Wisconsin Department of Transportation

Proposal #01: 1030-23-72, WISC 2018 330
N-S Freeway-CTH E Interchange
Mainline and Ramps
IH-94
Kenosha County

Letting of May 22, 2018

This is Addendum No. 02, which provides for the following:

GENERAL NOTES & QUANTITIES	SHEET 3 OF 29
505

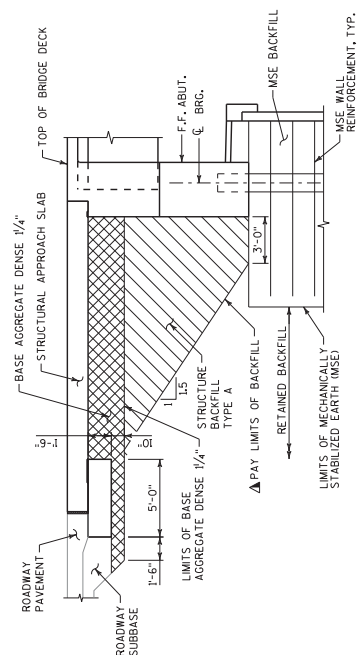
(ID 1030-24-79) Revised Plan Sheets	
Plan Sheet	Plan Sheet Title (brief description of changes to sheet)
505	Updated MQs on B-51-123
534	Updated MQs on B-51-124

Addendum No. 02
ID 1030-24-79
Revised Sheet 505
May 18, 2018

QUANTITY REVISION
 NO. DATE
 STATE OF WISCONSIN
 DEPARTMENT OF TRANSPORTATION
 STRUCTURE B-51-124
 SHEET 3 OF 30
 GENERAL NOTES & QUANTITIES
534

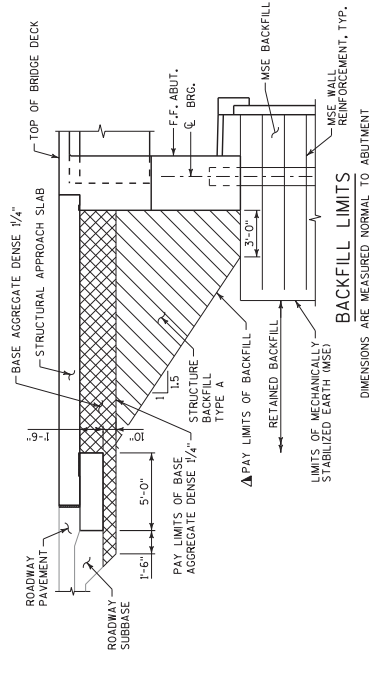
Addendum No. 02
 ID 1030-24-79
 Revised Sheet 534
 May 18, 2018
